- ، آنآن آن			OCD Arte	sla	L FORM	
(August 2007) (August 2007) UNITED STATES DEPARTMENT OF THE INTERIOR BUREAU OF LAND MANAGEMENT SUNDRY NOTICES AND REPORTS ON WELLS Do not use this form for proposals to drill or to re-enter an abandoned well. Use form 3160-3 (APD) for such proposals.					FORM APPROVED- OMB NO. 1004-0135 Expires: July 31, 2010 5. Lease Serial No. NMNM93457	
					SUBMIT IN TRI	PLICATE -Other instruction

1. Type of Well ☐ Oil Well 🔯 Gas Well □ Other					8. Well Name and No. B & C FEDERAL 25 1	
2. Name of Operator Contact: DAVID A EYLER NADEL & GUSSMAN PERMAN LLC E-Mail: DEYLER@MILAGRO-RESCOM					9. API Well No. 30-015-30842-00-S1	
3a. Address 3b. Phone No. (include area code) 601 NORTH MARIENFELD SUITE 508 Ph: 432-687-3033 MIDLAND, TX 79701 Ph: 432-687-3033					10. Field and Pool, or Exploratory LITTLE BOX CANYON

** BLM REVI	SED ** BLM REVISED **	BLMRI	EVISED ** BLM	REVISED	** BLM REVISE) **
						•

Permanent Abandonment of Federal Wells Conditions of Approval

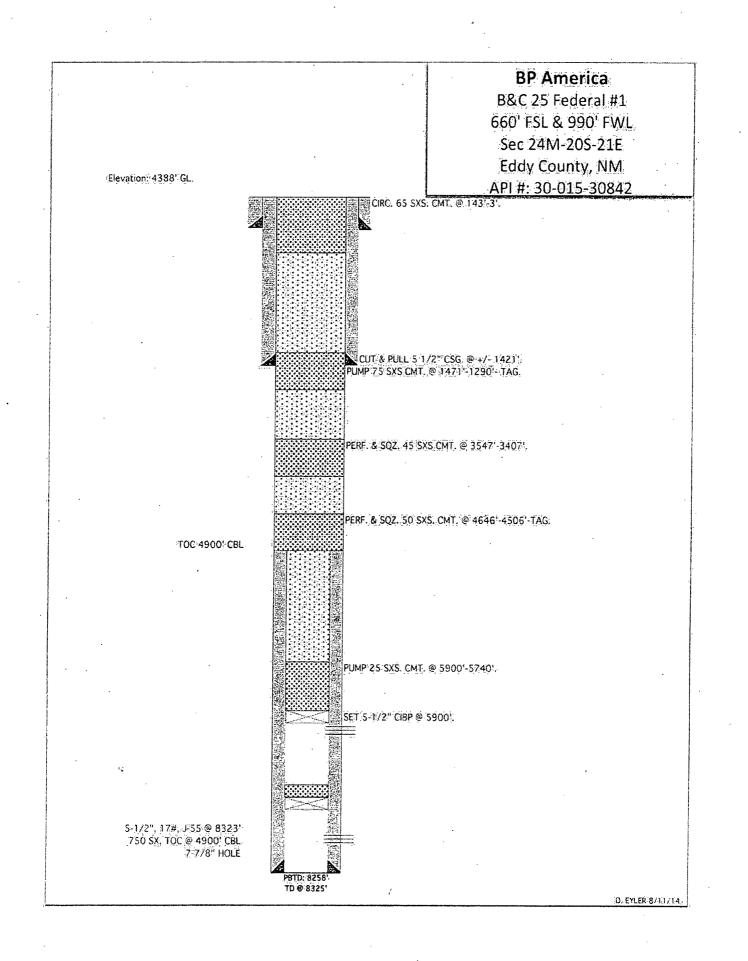
3) PERF. X ATTEMPT TO SC 4) CUT X PULL 5-1/2" CSG. (5) PUMP 75 SXS.CMT. (6) MIX X CIRC. TO SURF. 65 7) DIG OUT X CUT OFF WEL	ᡚ +/- / ,4742 4'. / ᠫ / ᢆ⊘ 71'4,290' (5-1/2''CSG.CUT, SXS.CMT. @ 143'-3'(13-3/8	9-5/8"SHO 3"CSG.SH	DE,T/GLOR.); TA			OCT 20 2014
	we will use the closi ocd rule 19.15.17. Cepted for record			0	ANK AND HAUL CO	
10-20-14 MCC	ACHED	•		FAPPROVAL		
 I hereby certify that the foregoing is Control Name (Printed/Typed) DAVID A End 	Electronic Submission #257 For NADEL & GUSSI Inmitted to AFMSS for proces	MANPERI	MAN LLC, sent to	the Carlsba	d	
	· .					<u>. </u>
Signature (Electronic S	THIS SPACE FOR	FEDER	Date 08/15/20		 SE	
	0 0					10-6-14
pproved By fames	1. Umes		Title SPE	7		Date
nditions of approval, if any, are attached tify that the applicant holds legal or equich would entitle the applicant to condu- tich would entitle the applicant to condu-	stable title to those rights in the sub	warrant or bject lease	Office CF	0
